UNITED STATES PATENT AND TRADEMARK OFFICE

10/698,134

Office Action Summary

DETAILED ACTION

Figure A.

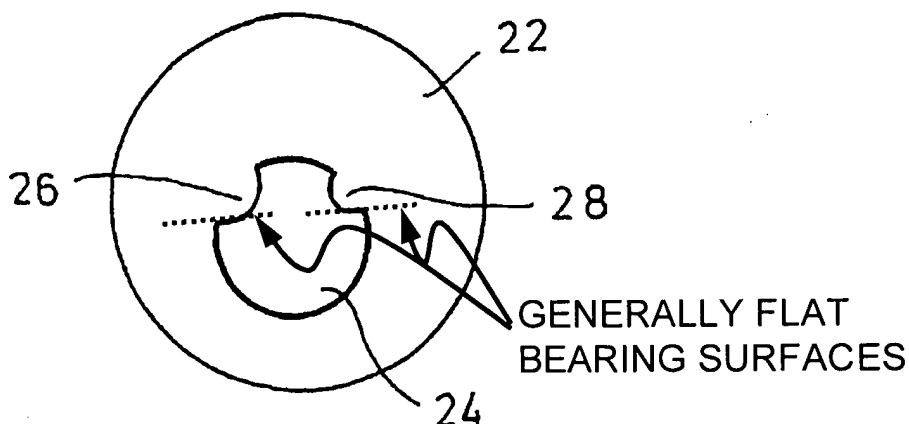
- a threaded fastener 1 defining a pair of longitudinal channels 18, 20, each channel defining a generally flat bearing surface and a concave curved portion (Figures 1-3, 6) (Figure A below) (col 4, lin 3-5)

4. Applicant argues none of the references disclose a fastener having channels defining a generally flat portion and a concave curved portion. Examiner disagrees and draws reference to Figure A of this Action, which is annotated Fig 3 of Hofschneider showing generally flat bearing surfaces and concave curved surfaces associated with the channels. Examiner also draws attention to Hofschneider Fig 6, which more clearly shows a flat portion and a concave portion of the slot, and notes Hofschneider discloses that individual features of the various exemplary embodiments may be used in any combination (col 4, lin 3-5).
